<b>Product/Process Change Notice (PCN)</b>																										
<input type="checkbox"/> Major Change <input checked="" type="checkbox"/> Minor Change																										
<p><b>PCN Number:</b> PCN_FrqXTAL_20250220</p> <p><b>Affected Series:</b> WE-XTAL</p> <p><b>Affected Part Number:</b> See table below</p> <p><b>PCN Date:</b> 2024-11-20 (YYYY-MM-DD)</p> <p><b>Effective Date:</b> 2025-02-20 (YYYY-MM-DD)</p>	<p><b>Change Category:</b></p> <input type="checkbox"/> Equipment/Location <input checked="" type="checkbox"/> General Data <input type="checkbox"/> Material <input type="checkbox"/> Process <input type="checkbox"/> Product Design <input type="checkbox"/> Shipping/Packaging <input type="checkbox"/> Supplier <input type="checkbox"/> Software																									
<p><b>Contact:</b> Product Management</p> <p><b>Phone:</b> +49 (0) 7942 - 945 5001</p> <p><b>Fax:</b> +49 (0) 7942 - 945 5179</p> <p><b>E-Mail:</b> pcn.eisos@we-online.com</p>	<p><b>Datasheet Change:</b></p> <input checked="" type="checkbox"/> Yes <input type="checkbox"/> No <p><b>Attachment:</b></p> <input type="checkbox"/> Yes <input checked="" type="checkbox"/> No																									
<p><b>DESCRIPTI

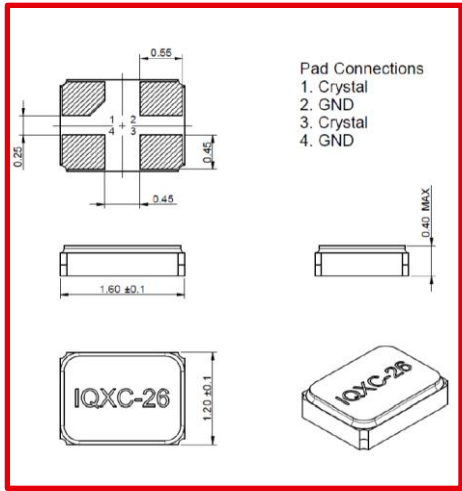
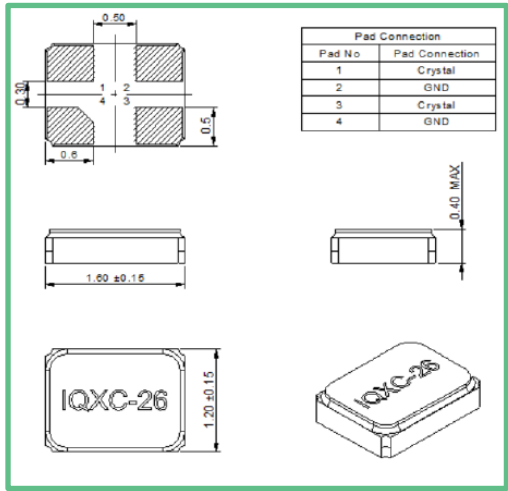
<b>DETAILS OF CHANGE:</b>														
1. Correction of the Packaging Details:														
Packaging Details	<p><b>Before</b></p> <p>Pack Style: Reel</p> <p>Tape &amp; reel in accordance with EIA-481-D</p> <p>Pack Size: 3,000</p>	<p><b>After</b></p> <p>Tape &amp; reel in accordance with EIA-481</p> <p>Quantities below the standard reel size to be supplied on cut tape.</p> <p>Standard Quantity: 3,000 Pieces</p>												
2. Correction of the Product Dimensions:														
Product Dimensions	<p><b>Before</b></p>  <p>Pad Connections          1. Crystal          2. GND          3. Crystal          4. GND</p>	<p><b>After</b></p>

Pad Connection		Pad No	Pad Connection	1	Crystal	2	GND	3	Crystal	4	GND
Pad Connection														
Pad No	Pad Connection													
1	Crystal													
2	GND													
3	Crystal													
4	GND													
L	1.60 ± 0.1	1.60 ± 0.15												
W	1.20 ± 0.1	1.20 ± 0.15												
H	0.40 max	0.40 max

Before	After
Solder Pad Layout

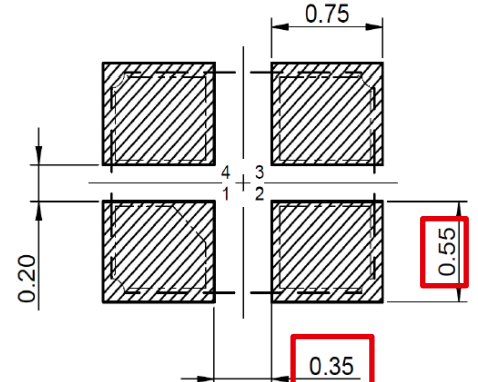
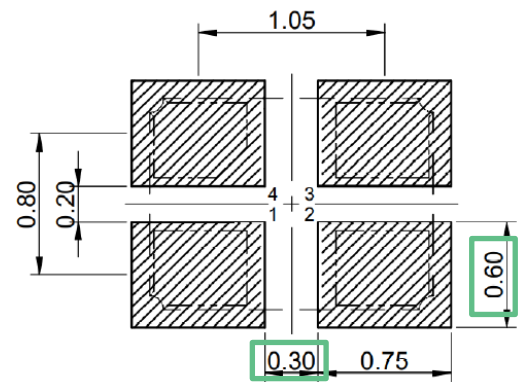
### 3. Correction of the Solder Pad Layout
